October 3, 2019

Dana Drake, P.E.
Environmental Program Manager
Waterway and Wetlands Program
Pennsylvania Department of Environmental Protection
Southwest Regional Office
400 Waterfront Drive
Pittsburgh, PA 15222-4745

**Re: Horizontal Directional Drill Reevaluation Report
Enhanced Alternative Crossing 5 Discussion
Loyalhanna Lake Crossing (HDD No. S2-0010)
Permit No. E65-973
Loyalhanna Township, Westmoreland County**

**Land Parcels Traversed by, and Private Water Wells (PaGWIS) Located within 450 feet of,
Alternative 5, Westmoreland County, PA**

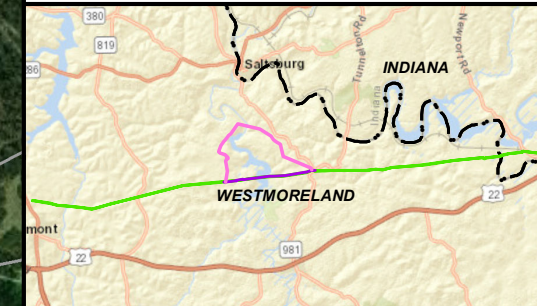
1. Provide information related to property owners that will potentially be affected by the reroute. This information should include identification of all property owners, property boundaries, and location of any public and private water supply sources.

SPLP has identified all property owners and property boundaries that would be potentially affected by the Alternative 5 route. Exhibit 1 presents a table listing all affected property owners and Exhibit 2 presents a figure depicting the boundaries of the associated properties. As identified in the table and figure, the Alternative 5 route traverses a total of 60 individual land parcels (tracts) inclusive of 45 individual private landowners (not including public road crossings), of which 56 tracts and 41 individual private landowners would be newly affected by the Pennsylvania Pipeline Project (PPP).

The Pennsylvania Department of Conservation and Natural Resource's PaGWIS water well data was queried to identify private water wells within 450 feet of Alternative 5. As of August 26, 2019, six (6) private water wells were identified within 450 feet of the centerline of Alternative 5. Exhibit 2 contains a figure depicting the PaGWIS water well locations within the 450-foot-wide buffer zone (as well as in the vicinity of) Alternative 5. The PaGWIS system is a helpful tool when identifying private water wells; however, previous queries of the PaGWIS data have proven to be less comprehensive than actual inquiry with the landowners. Accordingly, it is likely that additional water wells within 450 feet of Alternative 5 would be identified after landowner consultation.

Horizontal Directional Drill (Plan and Profile Drawing) Loyalhanna Lake Alternative 5

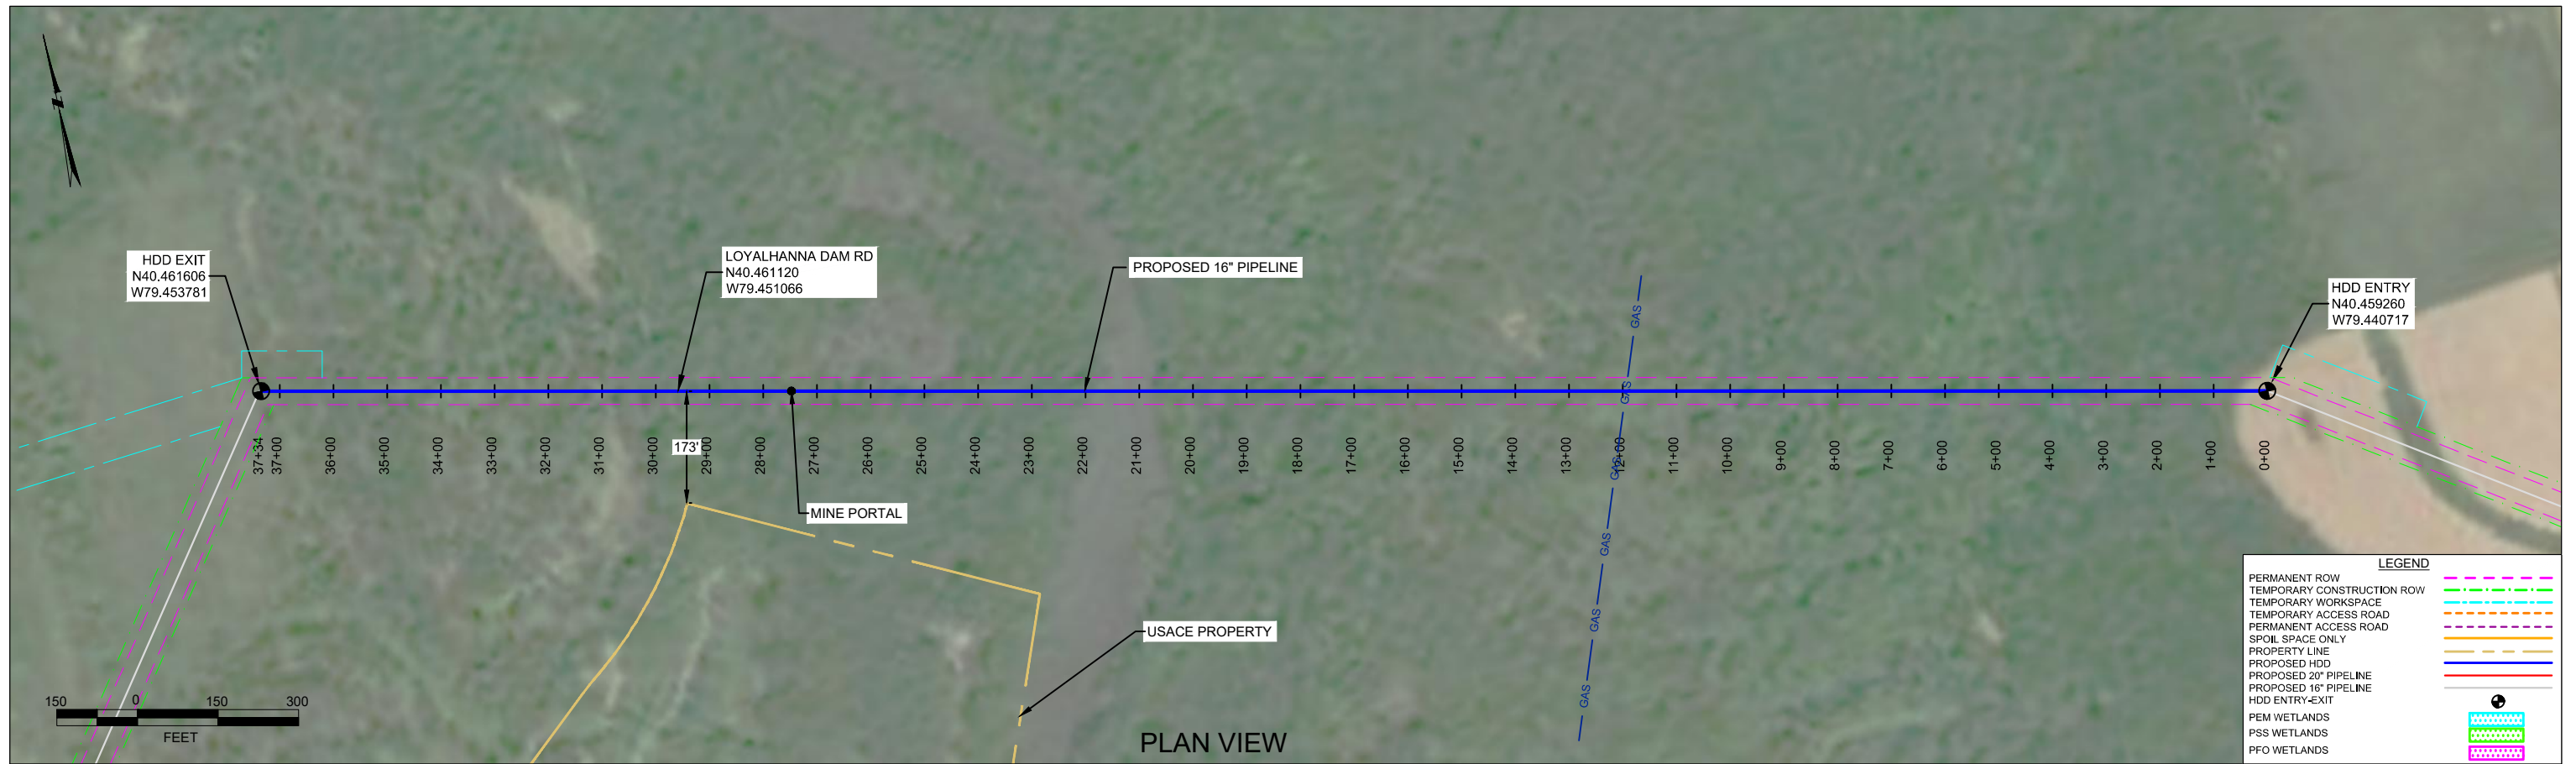
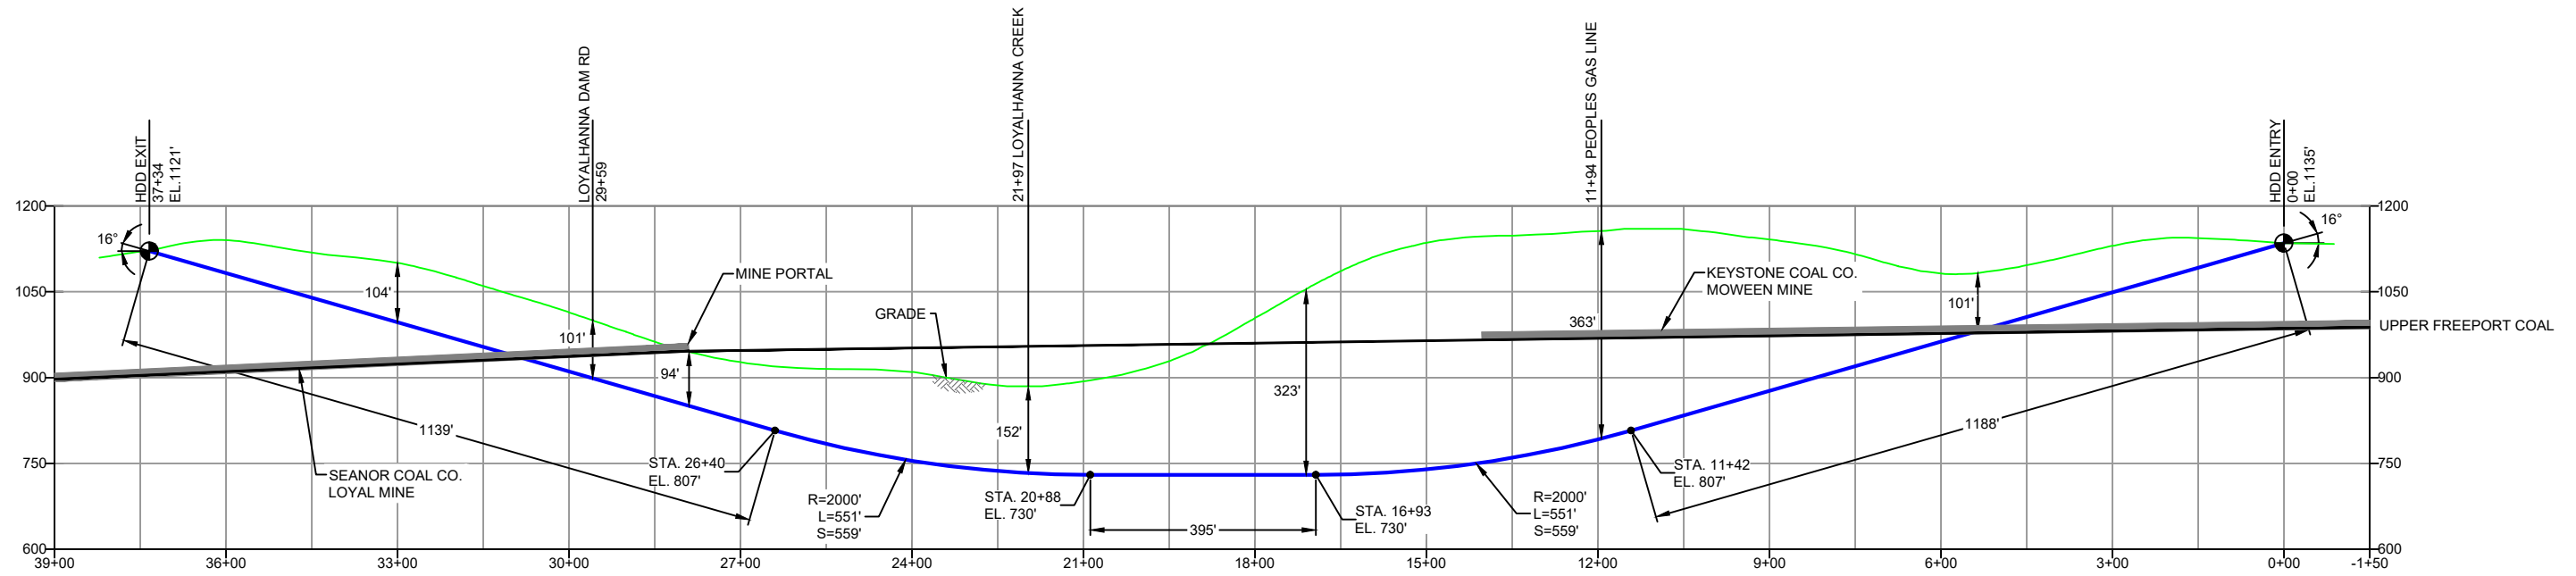
Horizontal Directional Drill (HDD)

As noted above, as part of SPLP's evaluation of Alternative 5, SPLP performed a more detailed desktop review of the originally-developed Alternative 5 routing alignment presented in SPLP's letter to the Department dated April 11, 2019. As a result of this review, SPLP developed a revised alignment for Alternative 5 that avoids crossing USACE property, Bush Recreation Area, and Loyalhanna Lake. Using this revised alignment, SPLP developed a site-specific HDD construction method plan for the approximately 164-foot-long bank to bank crossing of Loyalhanna Creek. A plan and profile drawing depicting this HDD plan is provided in Exhibit 4.

The subject HDD is aligned with surface topography to accommodate entry and exit workspaces on relatively level terrain, allow a reasonable HDD profile (or pipe radius), and ensure adequate pipe depth (152 feet) below the bed of Loyalhanna Creek to minimize the potential for an inadvertent return of drilling fluids to the creek. The HDD is 3,734 feet in length, and would avoid surface disturbances to Loyalhanna Dam Road, Loyalhanna Creek, and a buried natural gas pipeline. Due to the HDD exit workspace being located at a point of inflection in the revised Alternative 5 alignment, the HDD pullback string workspace would not be aligned with the pipeline right-of-way and thereby would require an approximately 3,700-foot-long temporary workspace located to the west of the HDD exit, which in turn would require substantial clearing of primarily forested land.

However, use of the subject HDD plan is not technically feasible due to the presence and HDD profile intersection of two existing and extensive subsurface (deep mining) coal mines, as depicted in Exhibit 5. Specifically, as depicted in Exhibit 4, the HDD profile intersects the existing Keystone Coal Company's Moween Mine on the east side of Loyalhanna Creek (at approximately 480 feet along the HDD profile and west of the HDD entry) at a depth of approximately 100 feet below ground surface. Also as depicted in Exhibit 4, the HDD profile intersects the existing Seanor Coal Company's Loyal Mine on the west side of Loyalhanna Creek (at approximately 3,079 feet along the HDD profile, and approximately 655 feet east of the HDD exit) at a depth of approximately 100 feet below ground surface; the HDD profile also traverses less than 100 feet below the portal (entrance) of this mine. The HDD profile intersects mined-out intervals of the Upper Freeport Coal seam, meaning the HDD profile would encounter empty space and mine pools

associated with the mined portions of these two deep mines. As the HDD construction method passing through the mines is infeasible without a high probability of significant fluid losses and potential impacts to the mine pool levels, the use of the HDD construction method through these mined intervals is technically infeasible.

**Environmental Resources in Vicinity of Potential Loyhalhanna Lake Alternative 5, Westmoreland
County, PA**

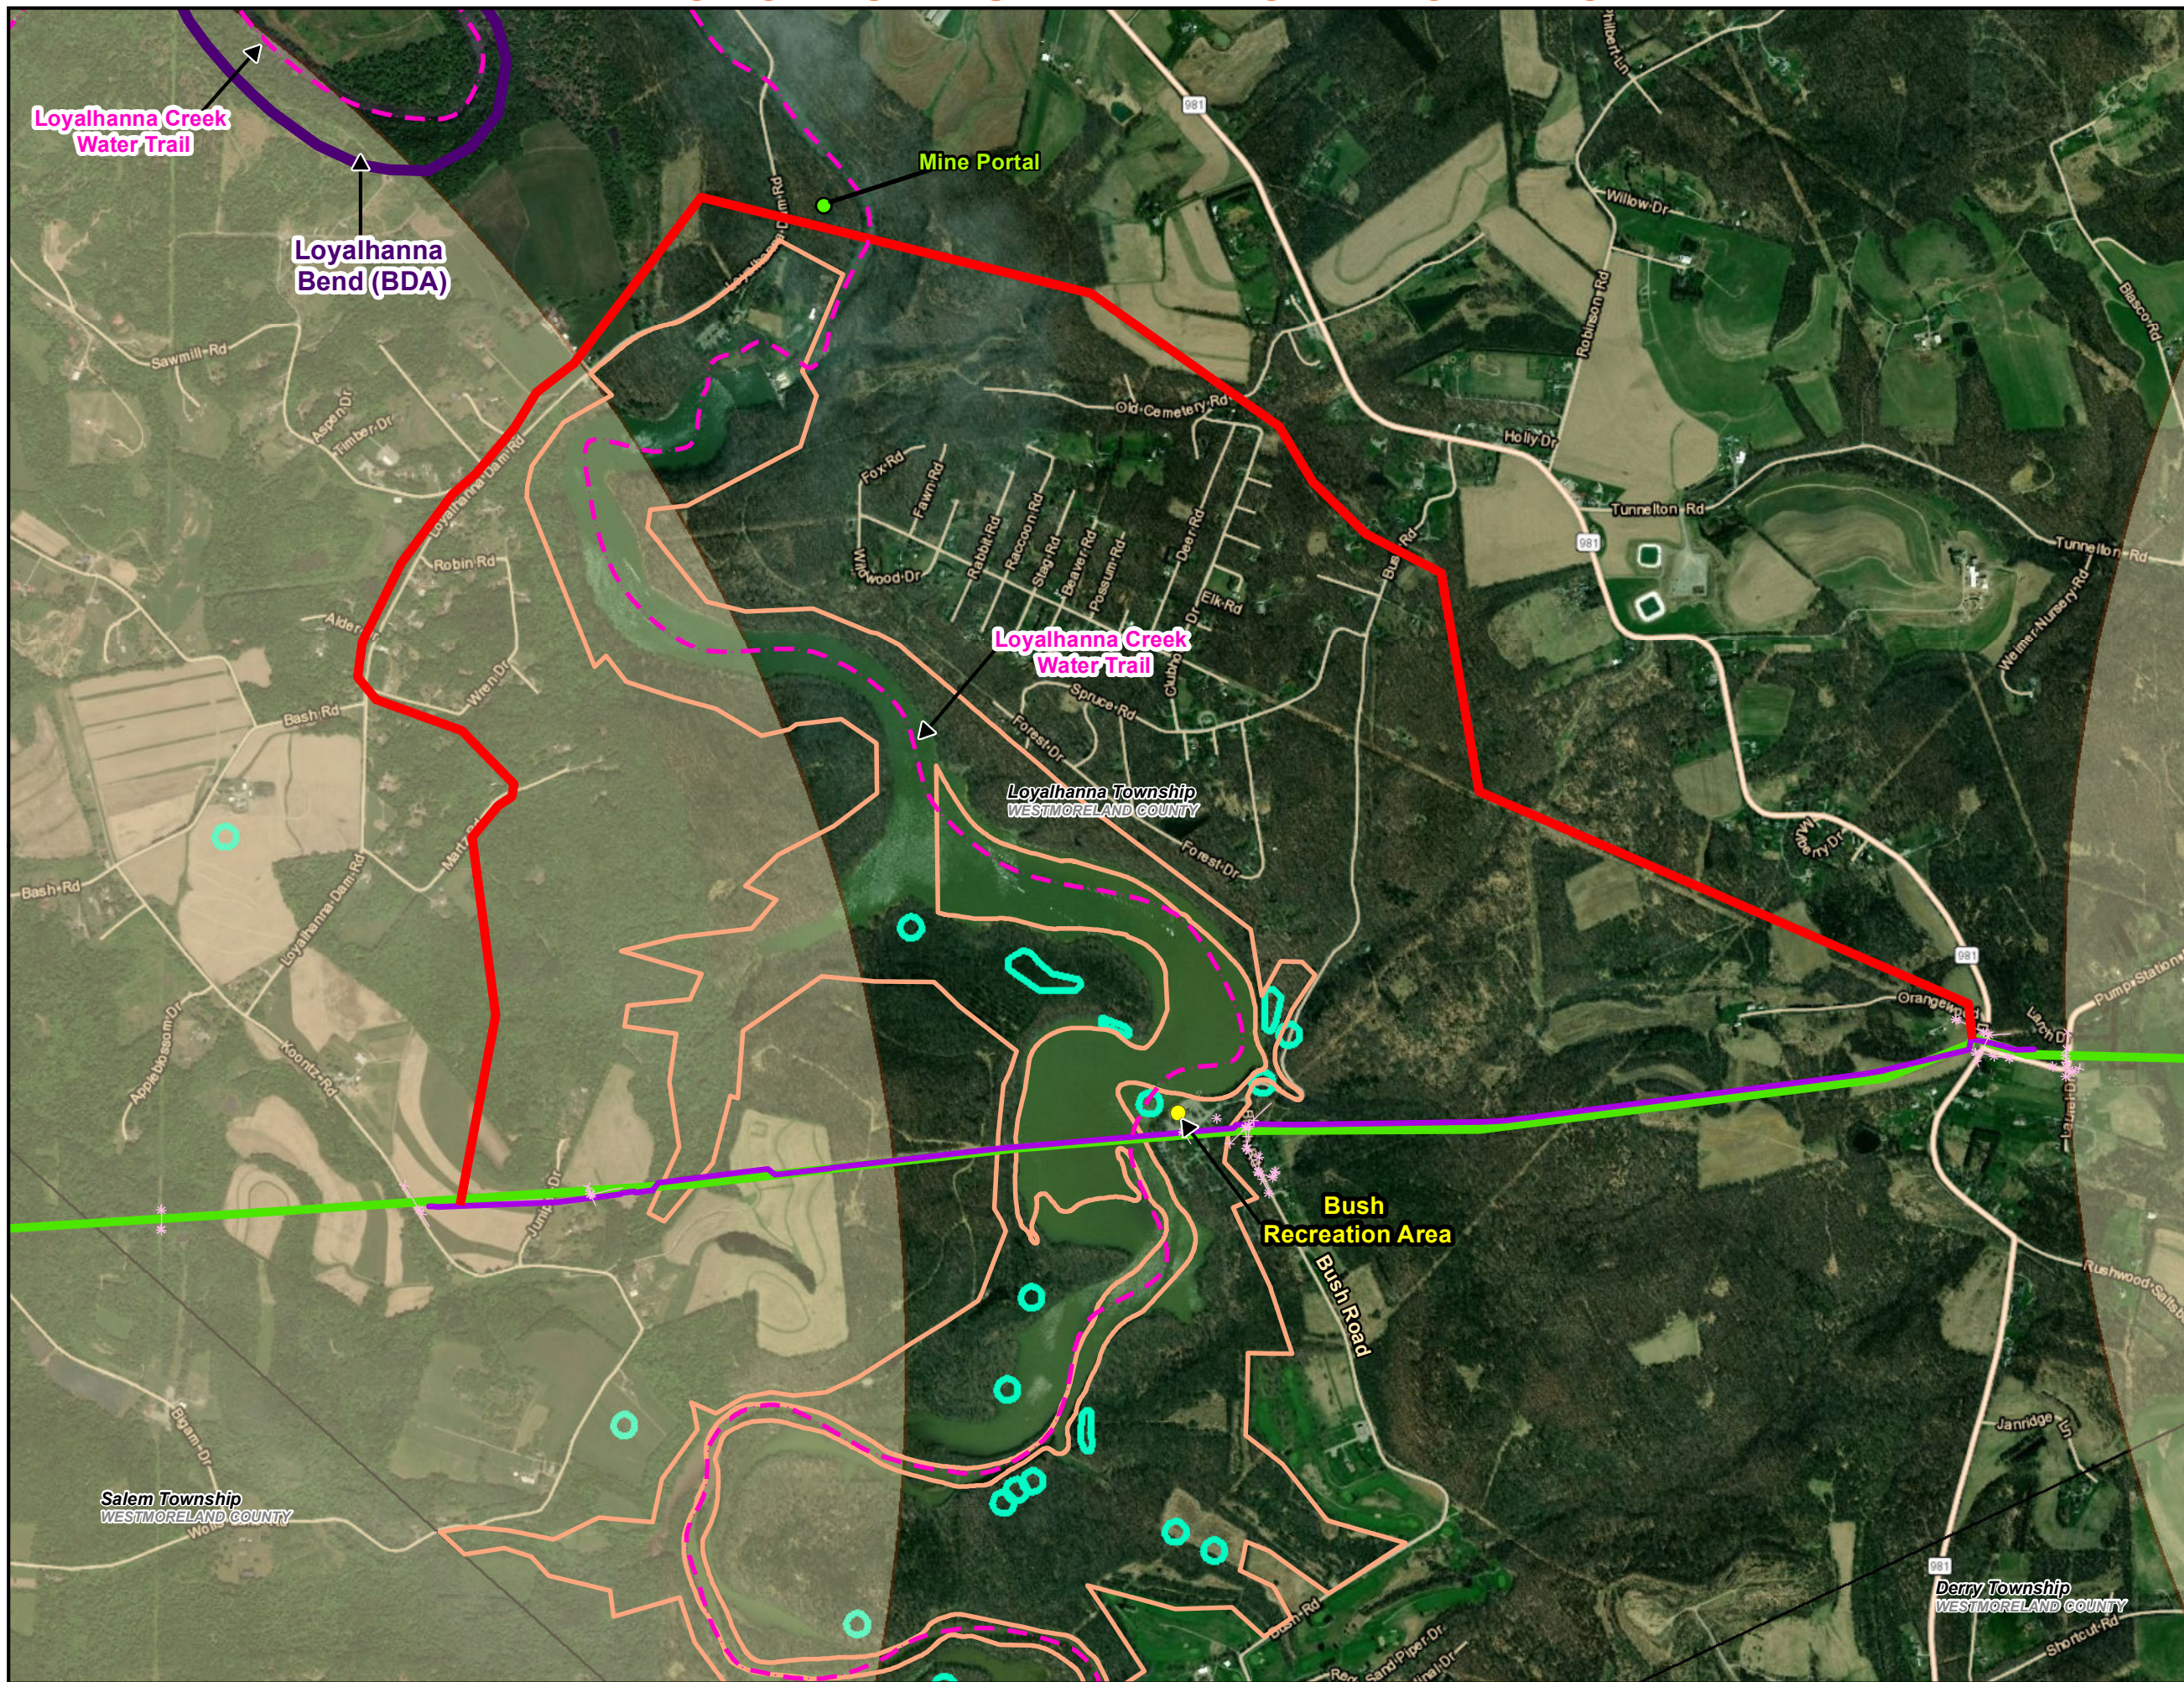
In addition to a feasibility analysis of the use of trenchless technologies to cross Loyalhanna Creek at the location of the revised Alternative 5 alignment, SPLP performed and herein presents an enhanced alternatives analysis consisting of a direct quantitative and qualitative comparison of the potential impacts to natural, cultural, and human environment resources of the revised Alternative 5 route using the open cut construction method and the Original Planned Crossing using HDD construction methods.

Special Land Uses – The Original Planned Crossing traverses approximately 0.25 mile of USACE property associated with the Loyalhanna Lake Recreation Area, including close proximity to the Bush Recreation Area, as depicted on Exhibit 6. This route also crosses the Loyalhanna Creek Water Trail, as depicted on Exhibit 6. However, the majority of this crossing avoids direct impacts to the USACE property and associated recreational uses, as well as the Loyalhanna Creek Water Trail, via use of the HDD construction method, and the USACE has reviewed and approved the entirety of the crossing and construction plans, including completion of the associated National Environmental Policy Act process. No other federal or state lands or special surface land uses are traversed by the Original Planned Crossing.
